SKYLAKE ACRES SUBDIVISION

APPLICATION NUMBER 10 DATE March 5, 2015

REQUEST Subdivision

DETAIL SITE PLAN

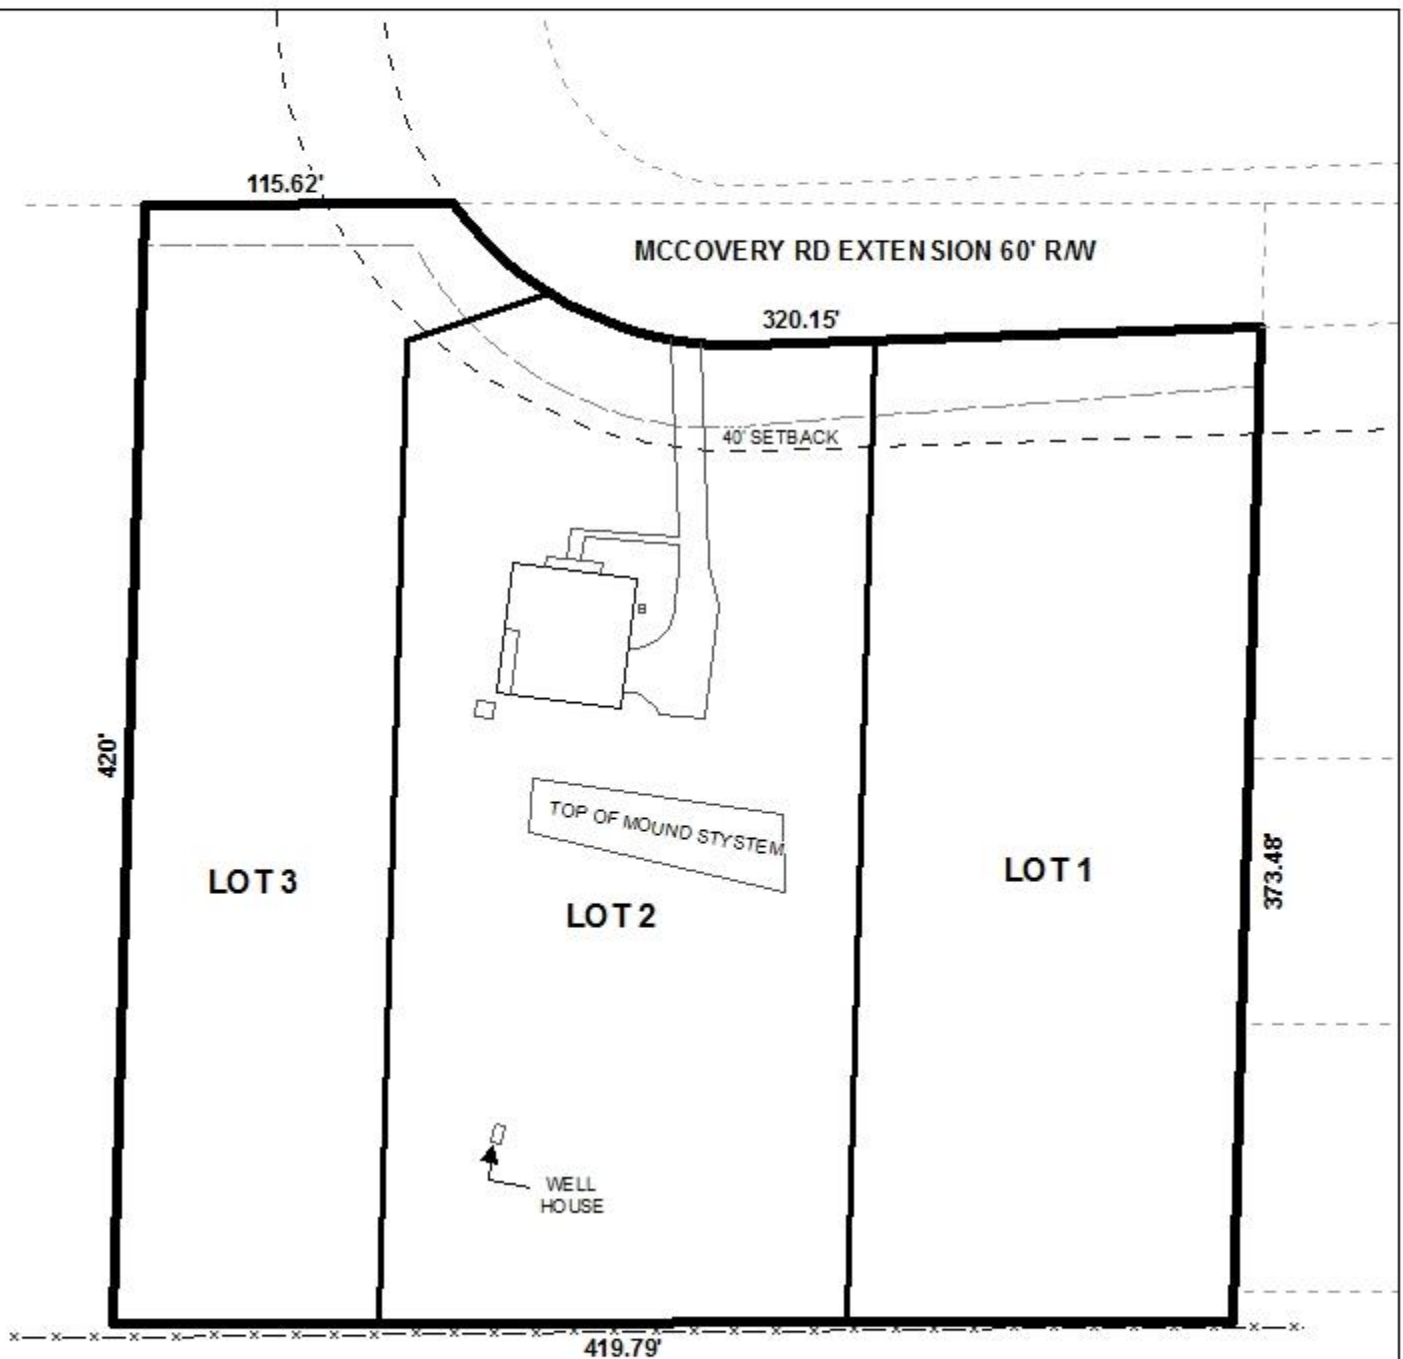
The dirt road has been paved since that time; however, the proposed Lot 3 in this request would require a waiver of Section V.D.3. of the Subdivision Regulations as the maximum depth of the lot would exceed 3.5 times the width of the lot at the building setback line. It should be pointed out that the proposed lot measures approximately 60'± at the building setback line and, due to the unique layout of the lot which results in a limited amount of frontage provided, any future subdivision of the lot should be prohibited until additional frontage along a public or private street is provided. This note should appear on the Final Plat if approved.

As proposed, all proposed lots exceed the minimum lot size requirements and a 40' minimum building setback line is depicted on the plat and should be retained on the Final Plat, if approved.

The site has frontage along McCovery Road Extension, a minor street without curb-and-gutter. As the existing right-of-way width is depicted as 60', no dedication would be required.

It should be pointed out that the Major Street Plan Component of the Comprehensive Plan depicts the general path of March Road Extension across the northwestern portion of the site;

however, the exact location of the street is unknown as there are no immediate plans for the street's construction. If approved, a note should be placed on the Final Plat stating that the site appears to be within the path of a proposed major street and may be impacted by the major street in the future.

The proposed Lot 2 is residentially developed and has one existing curb-cut to McCovery Road Extension. As a means of access management, the proposed lot should be limited to the existing curb-cut and the proposed Lots 1 and 3 should be limited to one (1) curb-cut each to McCovery Road Extension. The size, design and location of the proposed curb-cuts, along with any changes to the existing curb-cut, are to be approved by Mobile County Engineering and conform to AASHTO standards.

The preliminary plat depicts overhead utilities on the site which suggest there are easements that may not be depicted. In accordance with Section IV.C.2.h of the Subdivision Regulations, the Final Plat should be revised to illustrate all easements on the site, as necessary, along with a note stating that no permanent structure(s) can be placed or constructed in any easement, if approved.

With a waiver of Section V.D.3. of the Subdivision Regulations, the application is recommended for tentative approval, subject to the following conditions:

- 1) Depiction of all easements on the Final Plat, along with a note stating that no permanent structure(s) can be placed or constructed in any easement, if necessary;

- 2) Retention of the lot size information and 40' minimum building setback line on the Final Plat;
- 3) Placement of a note on the Final Plat stating: *(No future subdivision of Lot 3 is allowed until additional frontage is provided along a paved, public or private street.);*

- 4) Placement of a note on the Final Plat stating: *(The site appears to be within the path of a proposed major street and may be impacted by the major street in the future.);*

- 5) Placement of a note on the Final Plat stating: *(Lot 2 is limited to the existing curb-cut and Lots 1 and 3 are limited to one (1) curb-cut each to McCovery Road Extension. The size, design and location of the proposed curb-cuts, and any changes to the existing curb-cut, are to be approved by Mobile County Engineering and conform to AASHTO standards.);*
